ArevaEPRDCPEm Resource

Subject: Response to U.S. EPR Design Certification Application RAI No. 277, FSAR Ch. 9, Supplement 18
Sent Date: 6/30/2011 6:10:54 PM
Received Date: 6/30/2011 6:11:00 PM
From: WILLIFORD Dennis (AREVA)

Question 09.04.01-1:

Figure 2.6.8-1—Containment Building Ventilation System Functional Arrangement

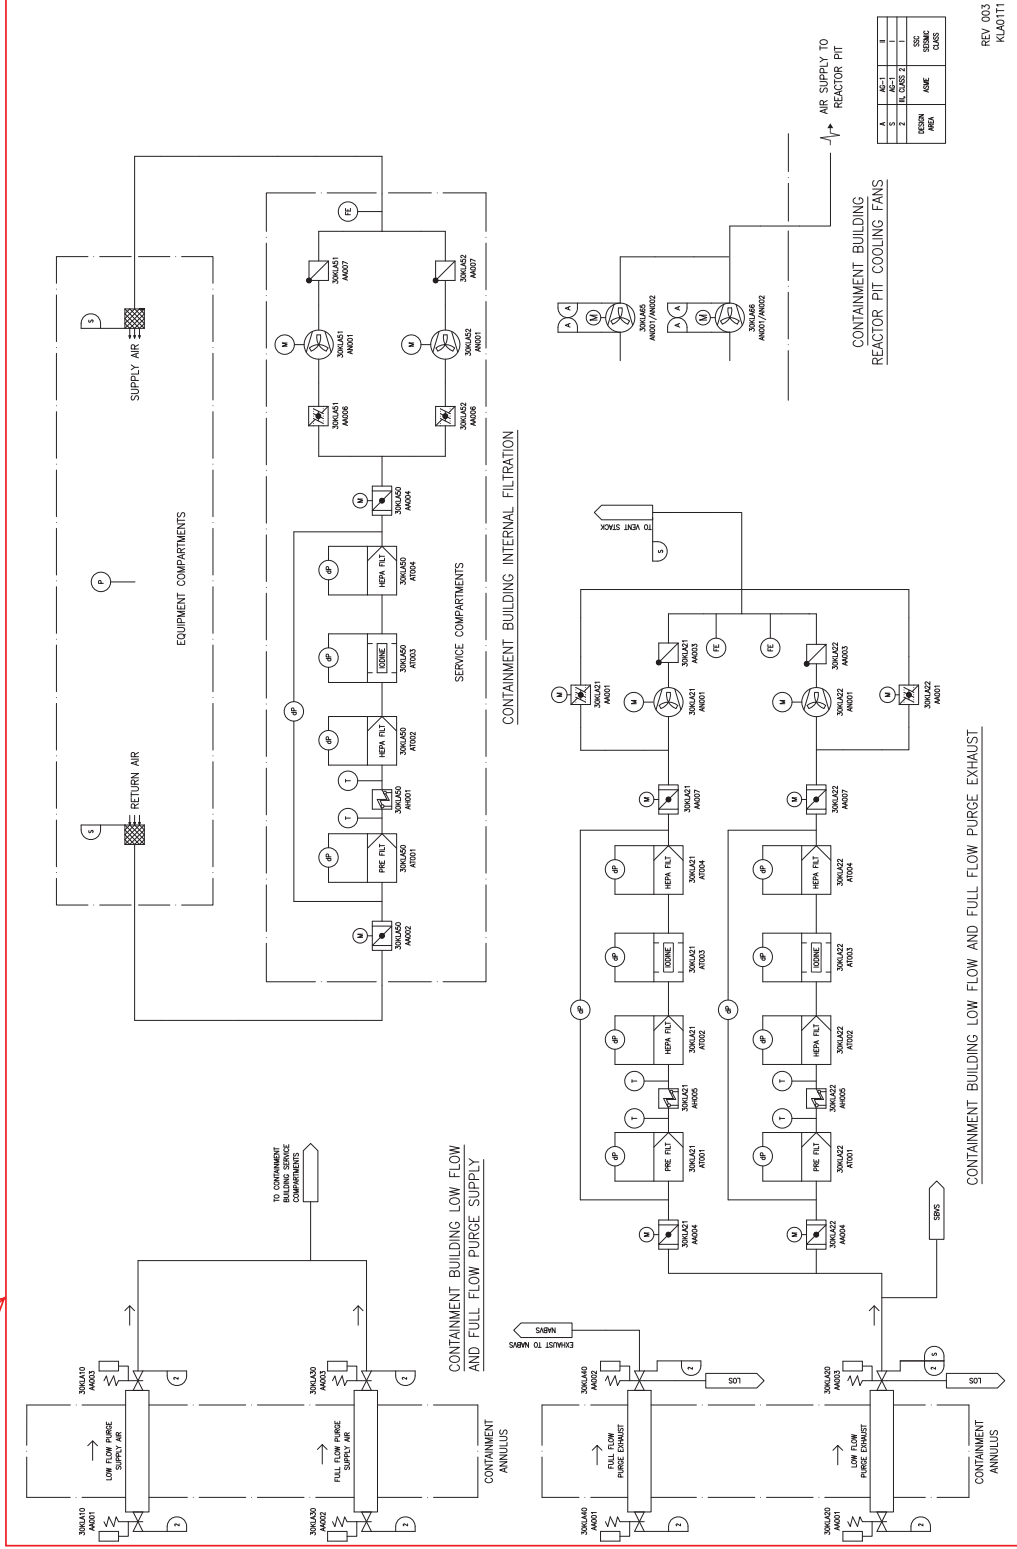
Question 09.04.03-3:Clarify the role of the CBVS in meeting GDC 41 and GDC 42

The FSAR in section 9.4.7.1 states “The containment purge subsystems remove radioactive materials via iodine filtration trains prior to release to the atmosphere (GDC 41).” However, the containment building ventilation system does not meet the requirements for General Design Criterion 41, because it is not designated as a safety system. Although these systems are designed to Seismic Category I requirements, it is not designated as a safety system. The FSAR in section 9.3.7.3 states, “The CBVS is not an engineered safety feature and has no safety-related function except the containment isolation and low-flow purge.” This is inconsistent with crediting it as the system designed to meet GDC 41 which requires a safety system capable of performing the safety function assuming a single failure and loss of offsite power. The applicant needs to clarify the role of the CBVS in meeting GDC 41. The applicant needs to state how GDC 41 is met (this is typically described in FSAR section 6.2.5 and 6.5). If the CBVS system is credited the applicant needs to describe the meeting of the requirements of GDC 41.

U.S. EPR FSAR Tier 1, Section 2.6.8, Table 2.6.8-2—Containment Building Ventilation System Equipment Mechanical Design, and Figure 2.6.8-1—Containment Building Ventilation System Functional Arrangement will be revised to clarify the safety function of the CBVS low flow purge function.

U.S. EPR FSAR Tier 2, Section 9.4.7.1 will be revised to clarify that the CBVS low flow purge subsystem performs a safety function and is an engineered safety feature ventilation system. U.S. EPR FSAR Tier 2, Sections 9.4.7.2.1, 9.4.7.2.2 and 9.4.7.3 will also be revised to provide further clarification.
